Reference: H16/0301/93

Description: Erection of 63 dwellings complete with roads and footpaths

Location : Land west of Woolram Wygate Spalding
 Lincs

PLANNING AMENDMENT

STAMFORD HOMES
WYATE PARK, SPALDING.

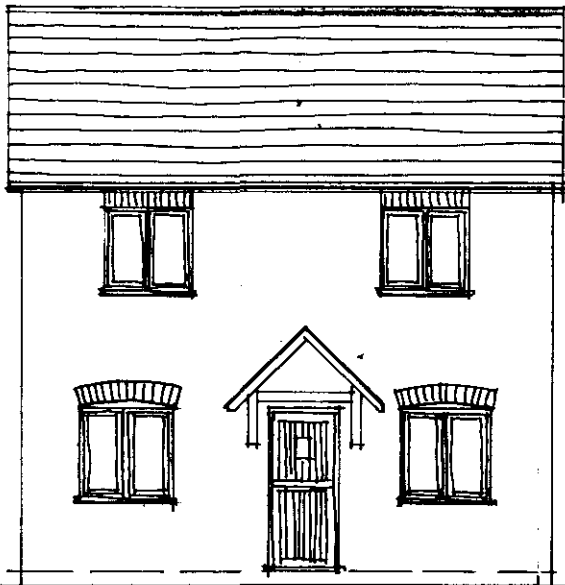
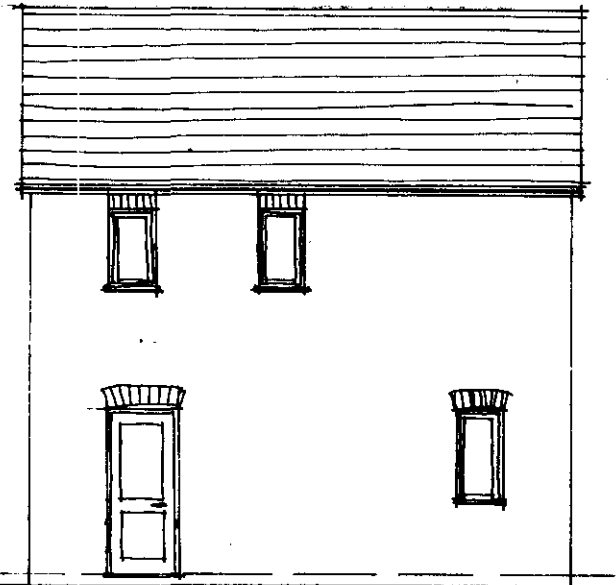
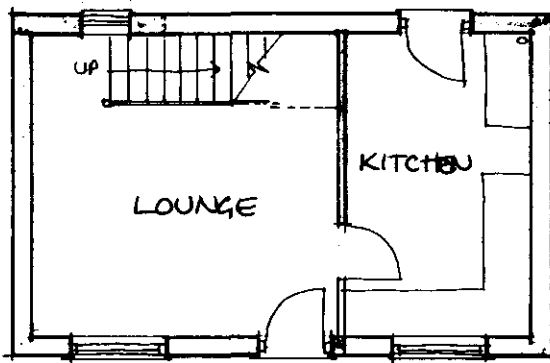
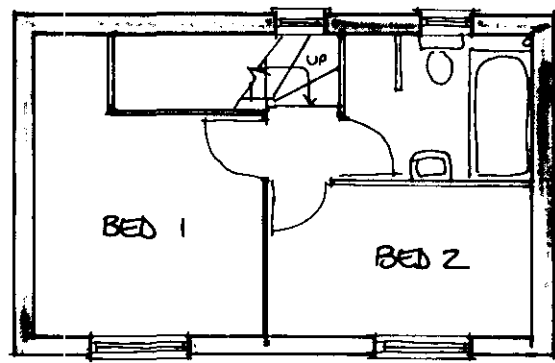
Further to your telephone conversation with Mr Blackburn, I am pleased to enclose 4No copies of our drawing No S225.05 showing the detached house type LJ on Plot 37. I trust this answers your query.

S 225 - 04

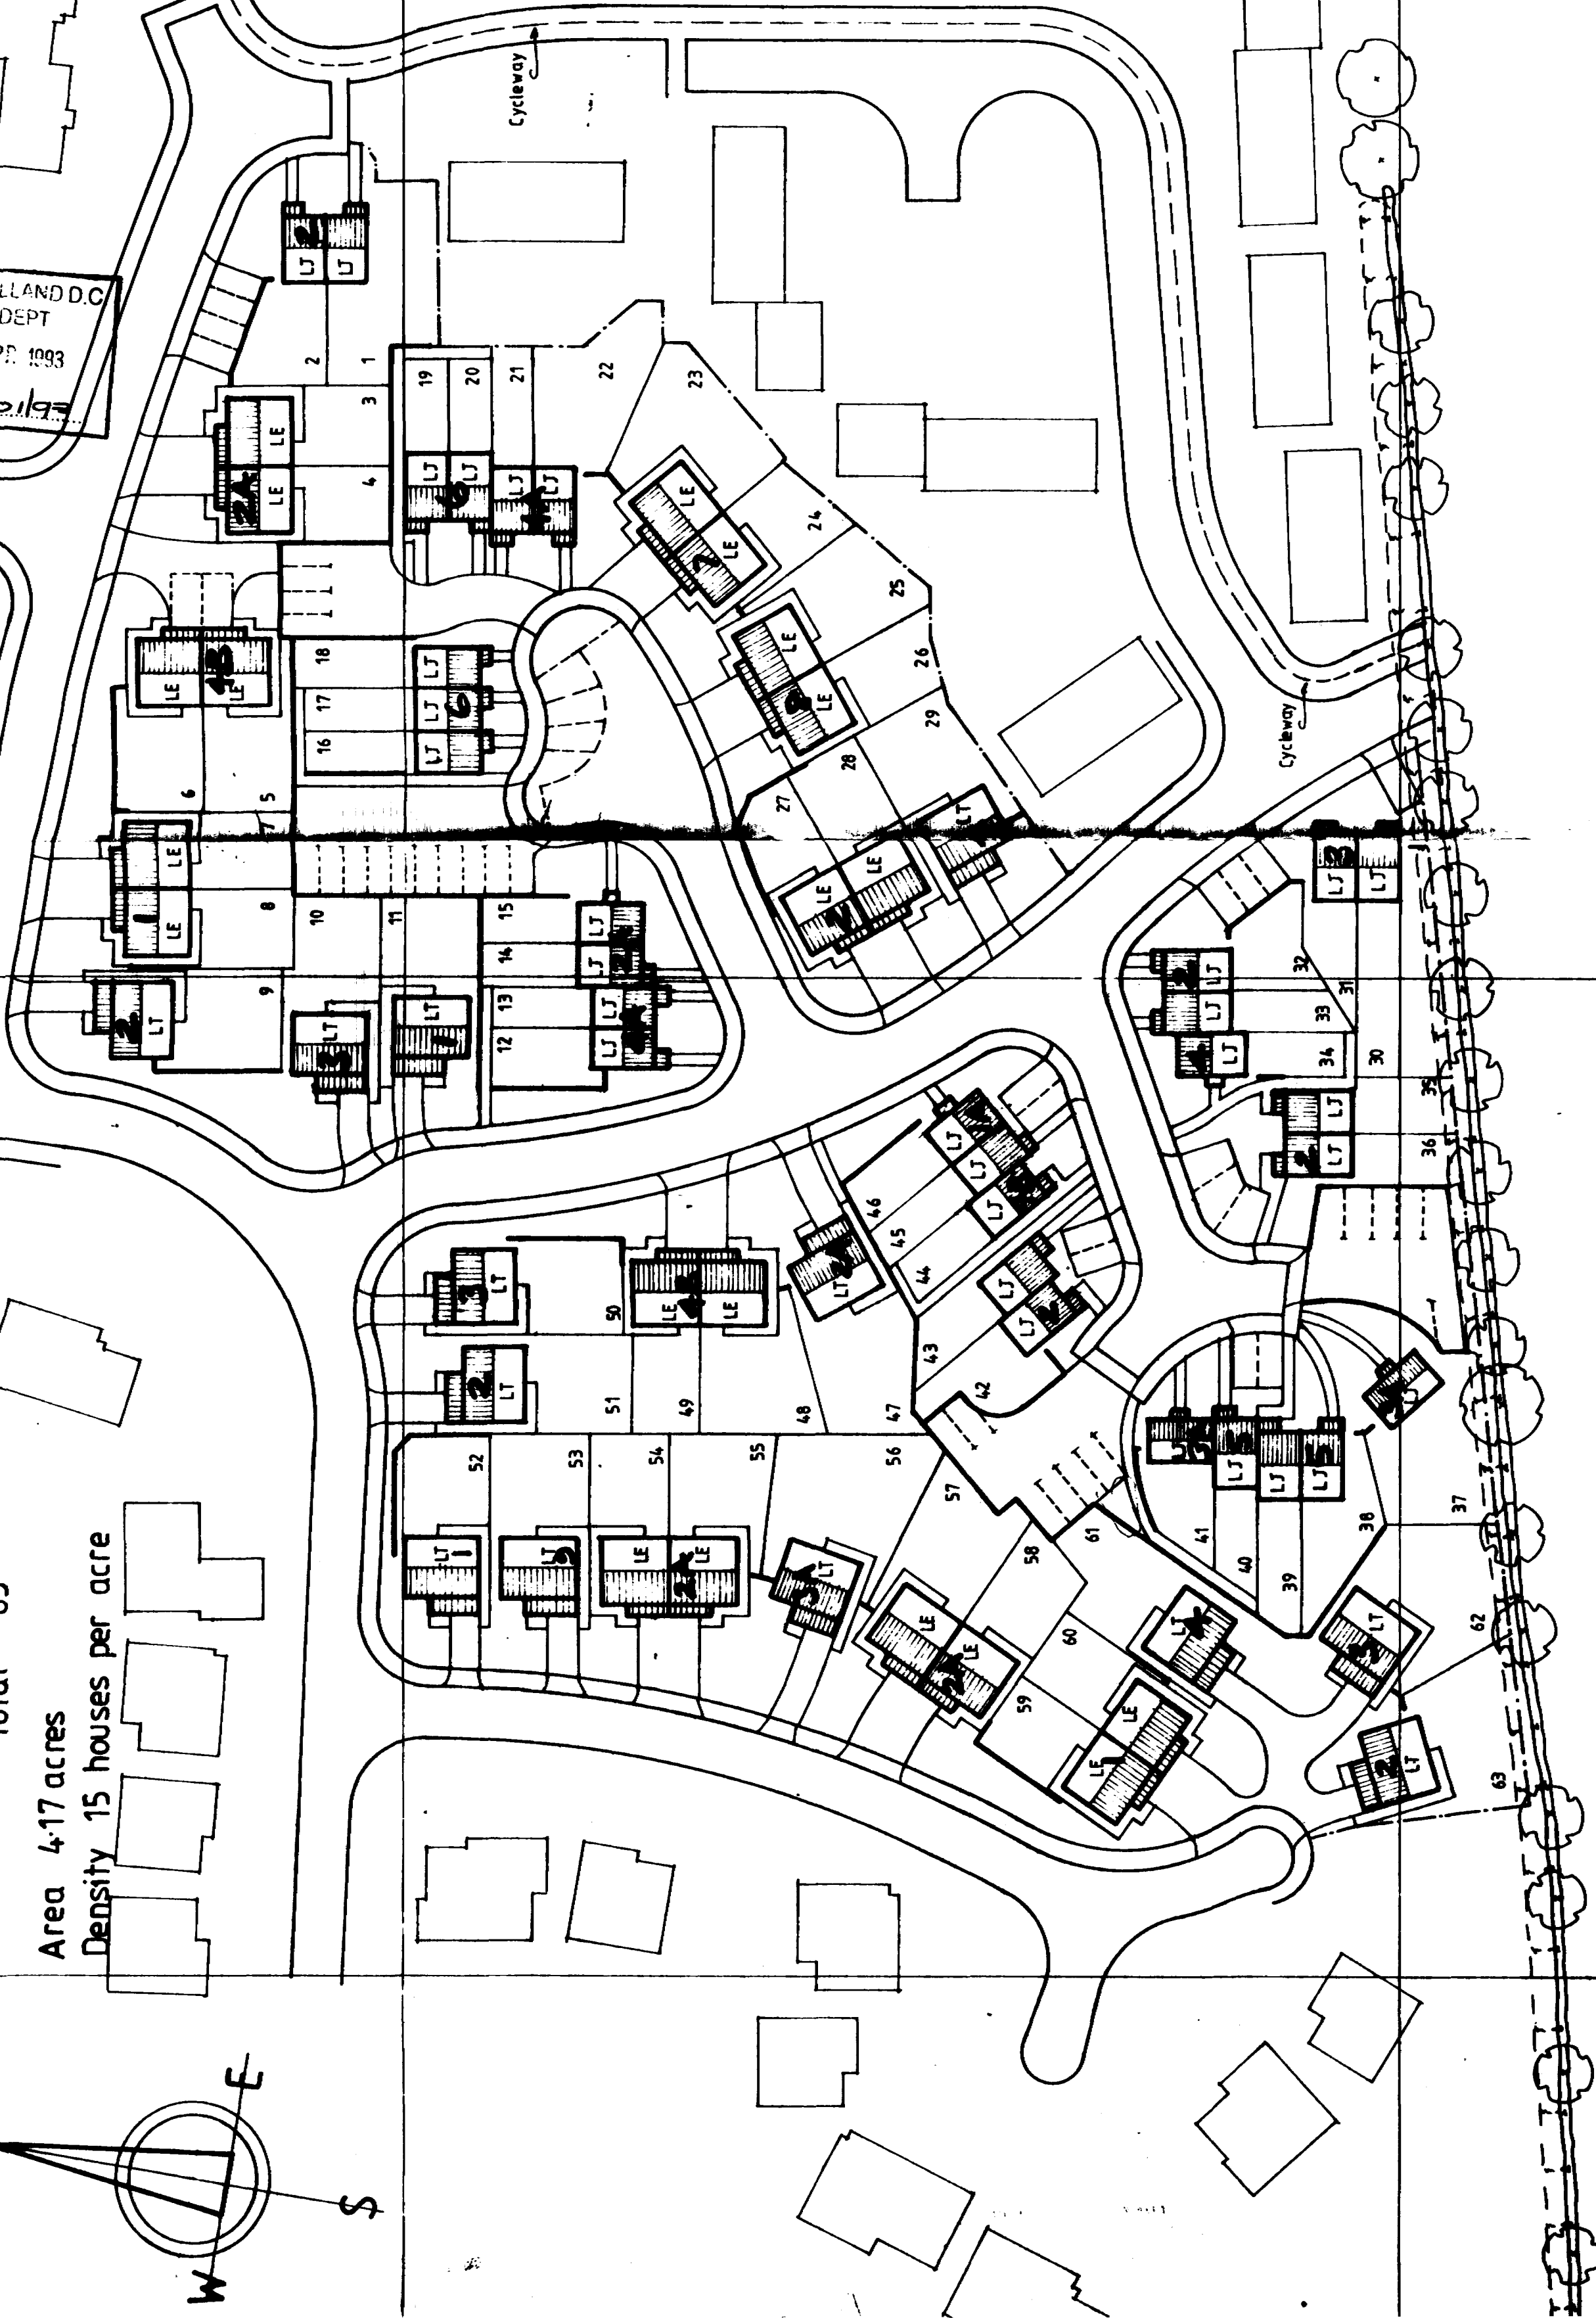
Further to our letter of 26 March 1993, I enclose 4No copies of details of the brick and tile combinations for the above together with 4No copies marked up copies of drawing No S225.04 indicating their distribution.
